ATB-20/531-
21.86/22.11
PART 3

SIGNALIZED CLOSURE PLAN (ATB-531-22.11 EB LANE)

DESIGN AGENCY ODOT --- DISTRICT 4 PLANNING & ENGINEERING	DATE MM/DD/YY MJA	REVIEWED MJA STRUCTURE FILE NUMBER 0406813	DRAWN CMR REVISIONS CMR	DESIGNED CMR CHECKED MJA
STRUCTURE GENERAL NOTES ATB-531-2211 OVER CONNEAUT CREEK				
ATB-20/531-21.86/22.11 PART 3 PID No. 98903				
4 / 15				
24 36

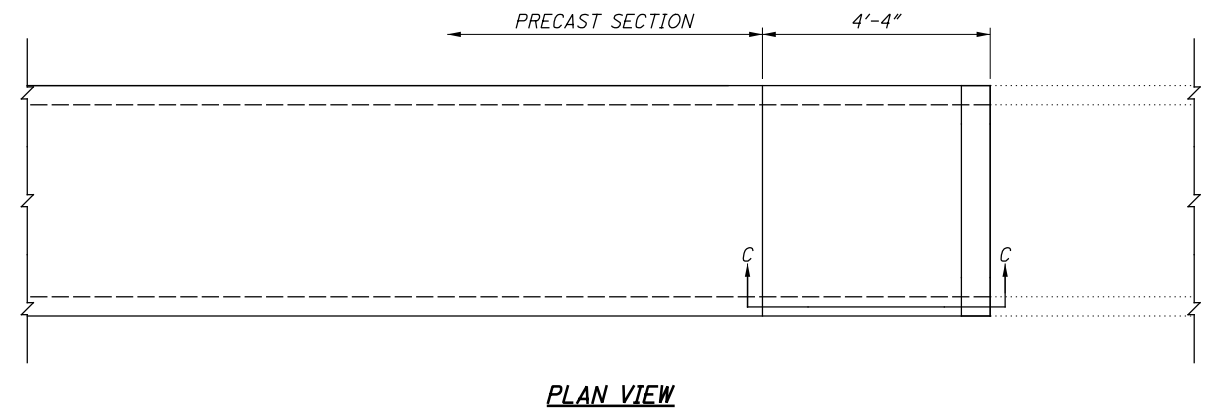
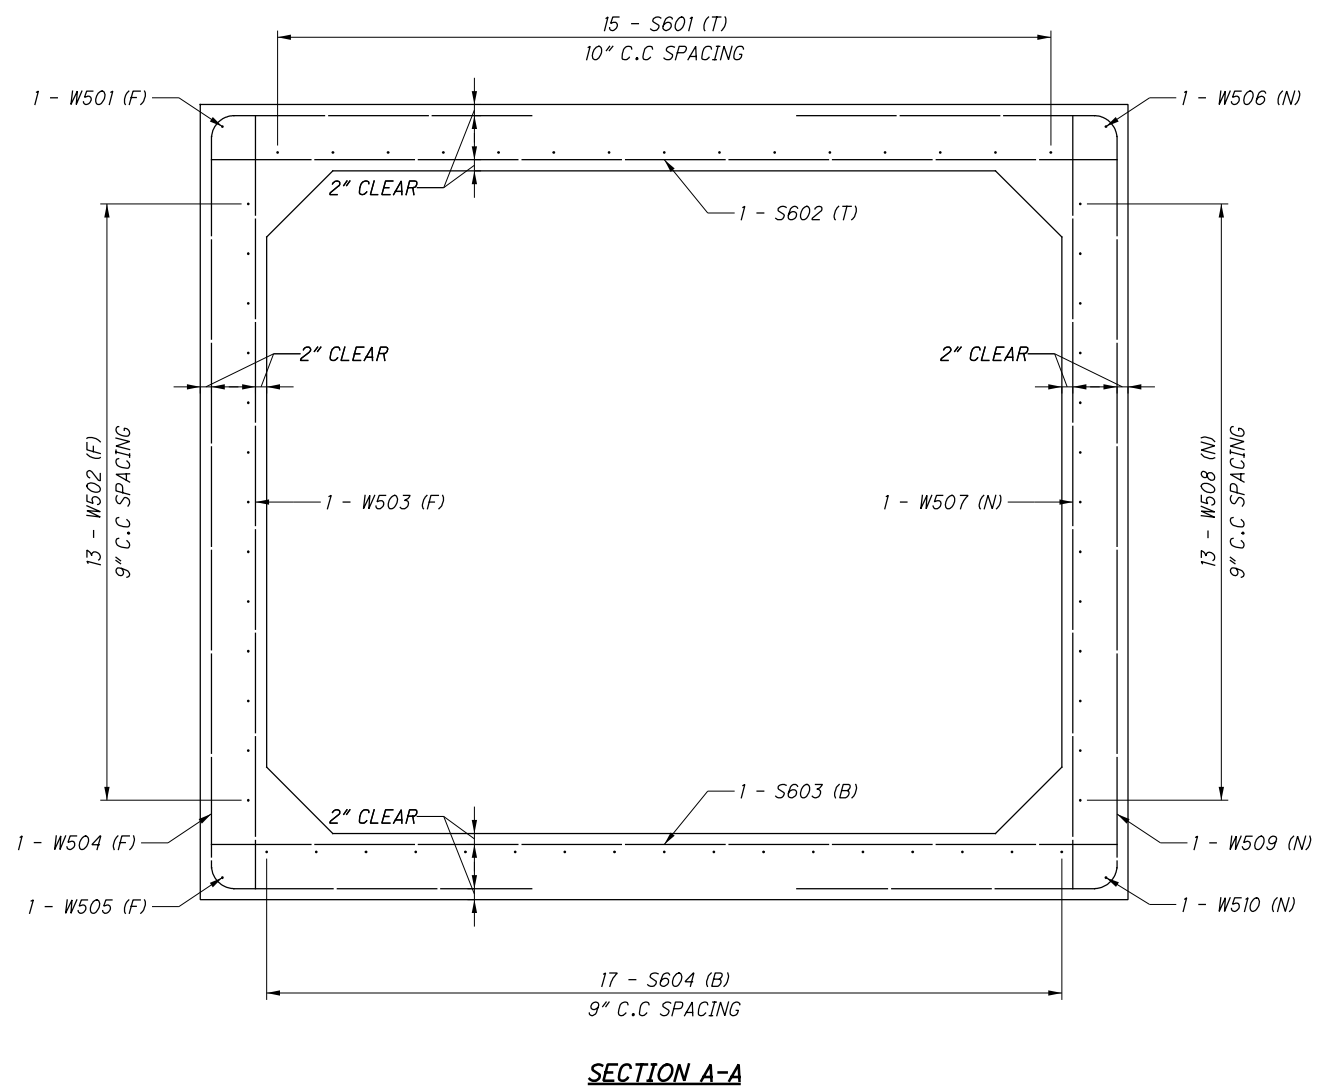
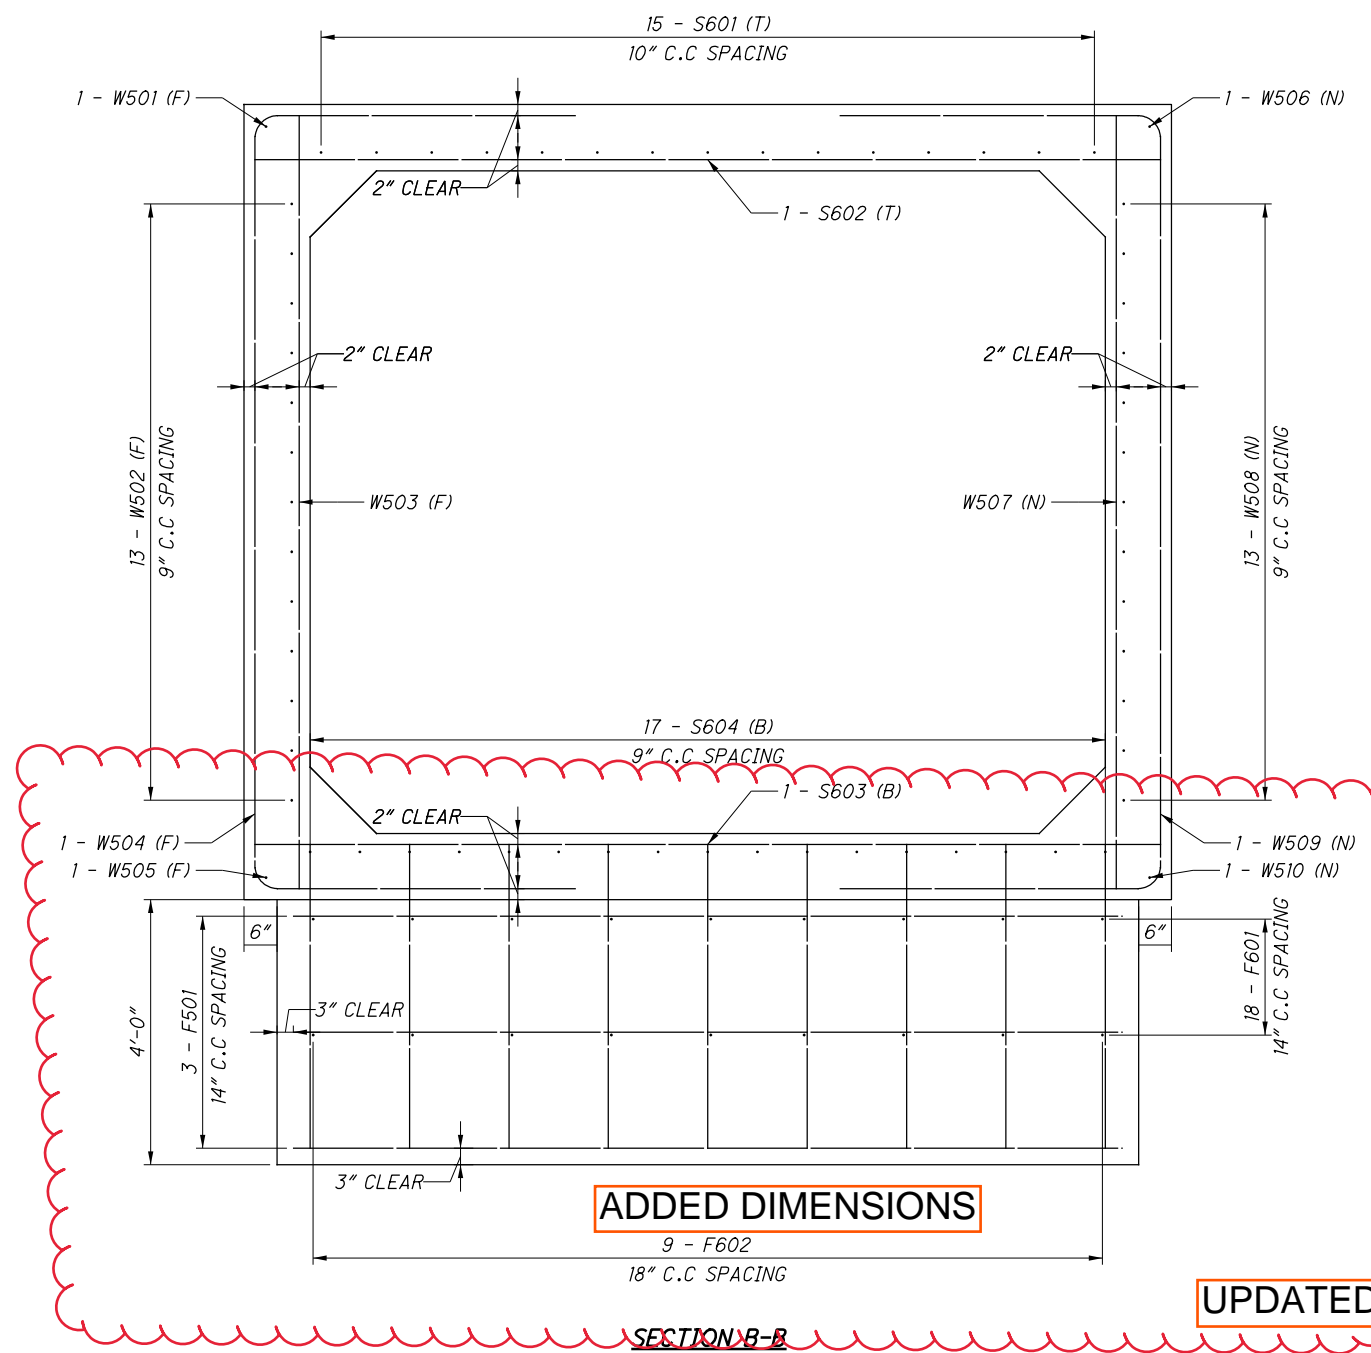
ADDED DIMENSIONS

SECTION C-C

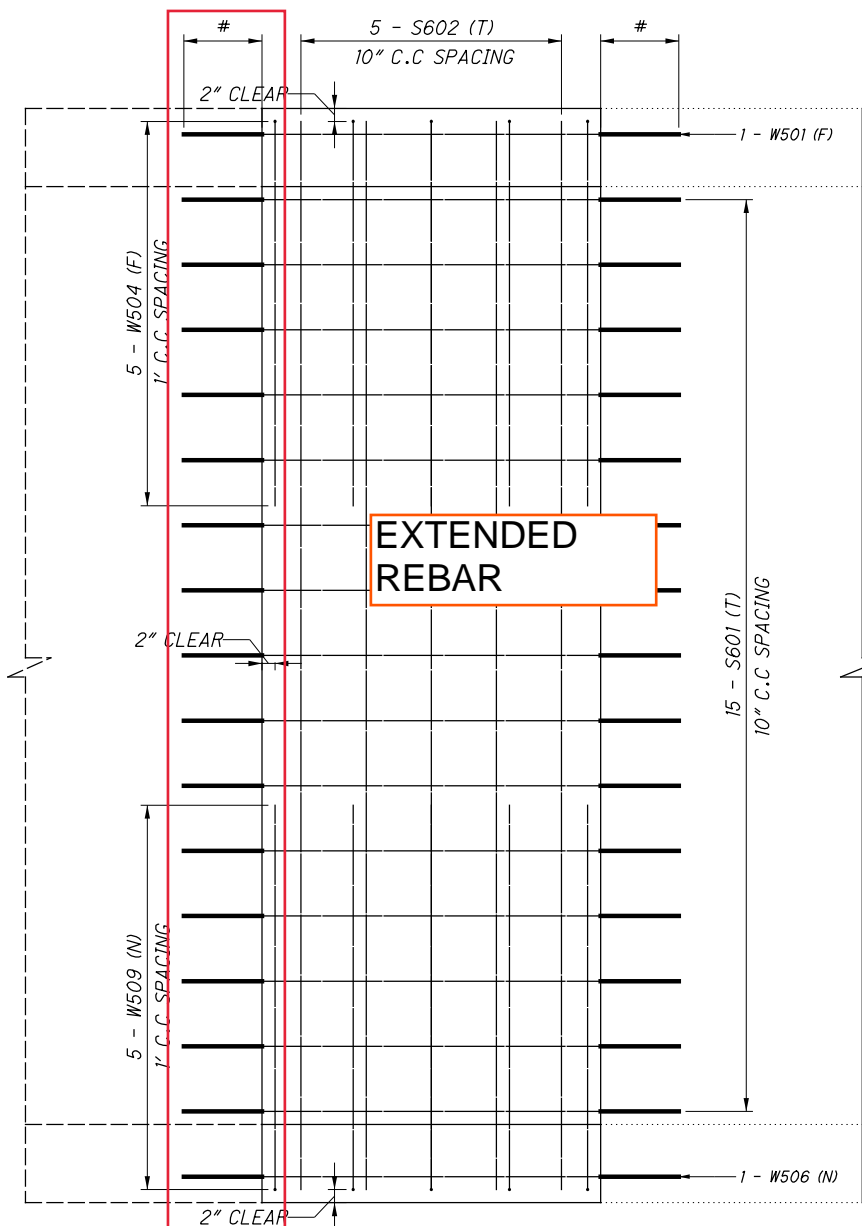
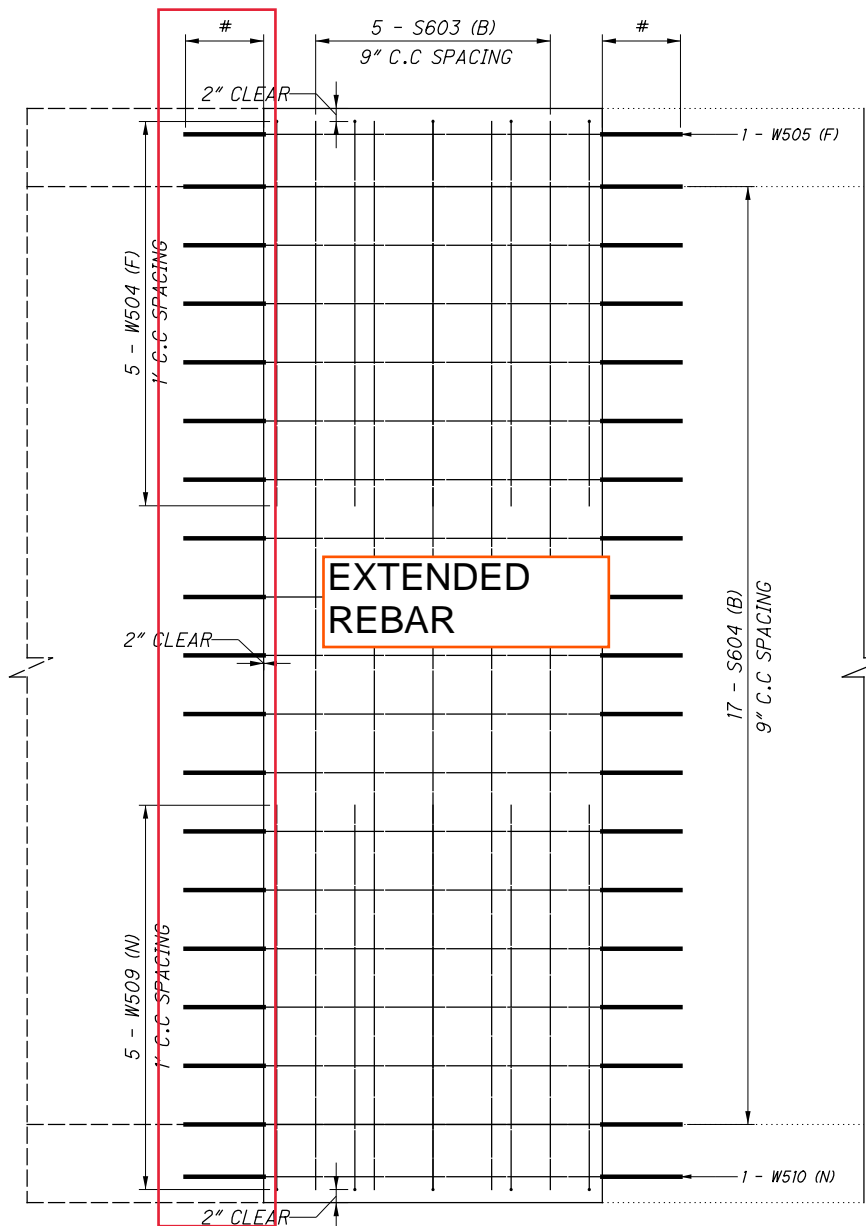
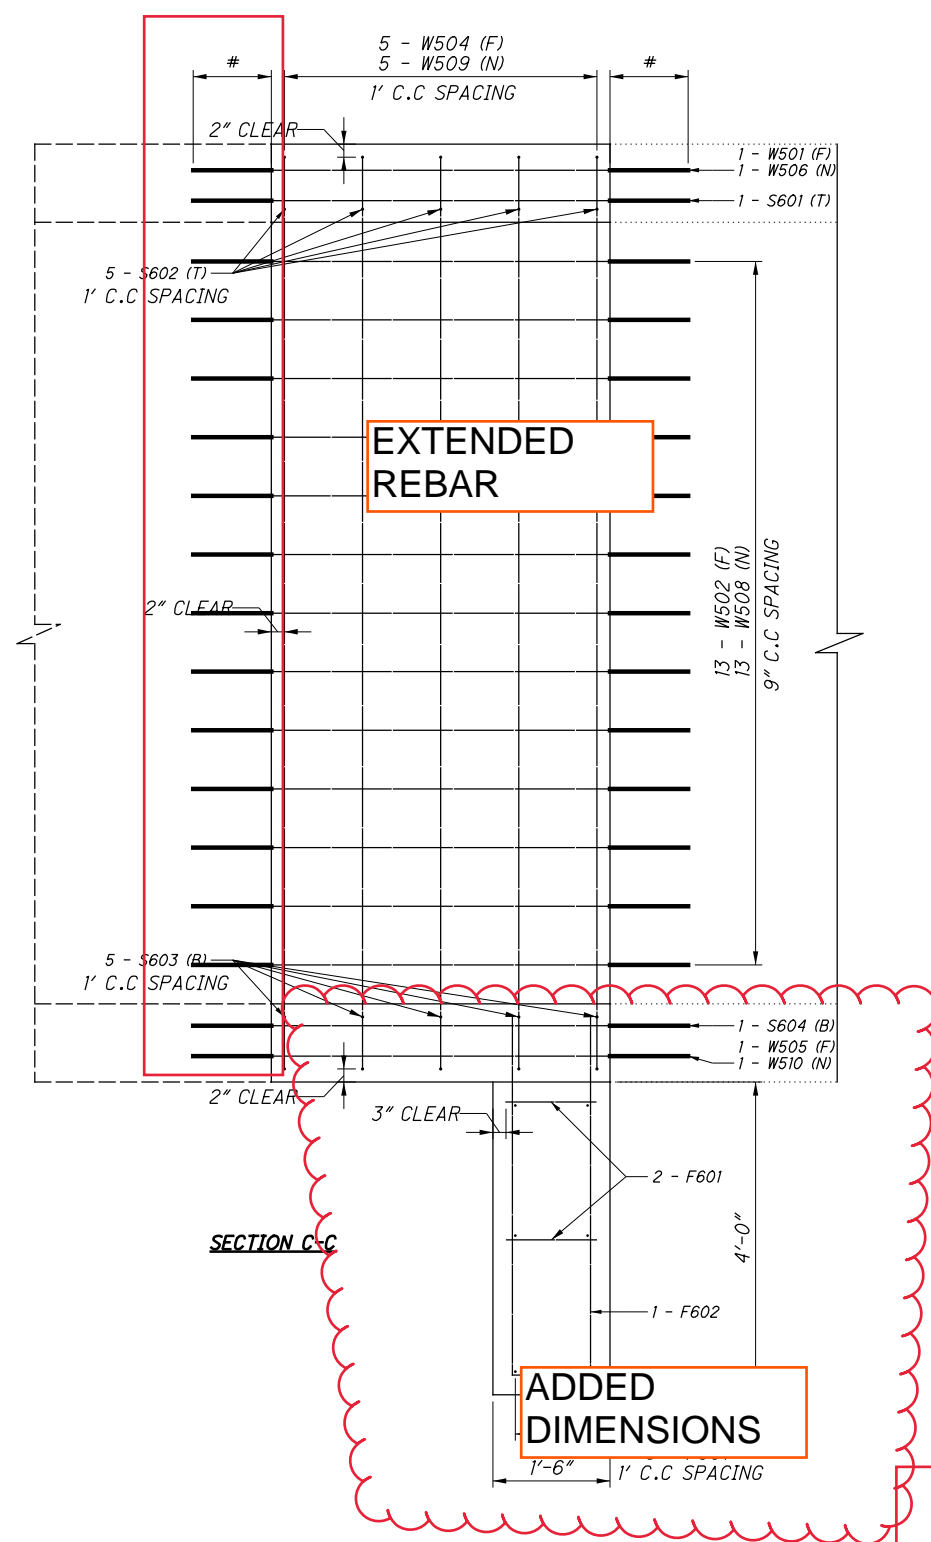
ADDED DIMENSIONS
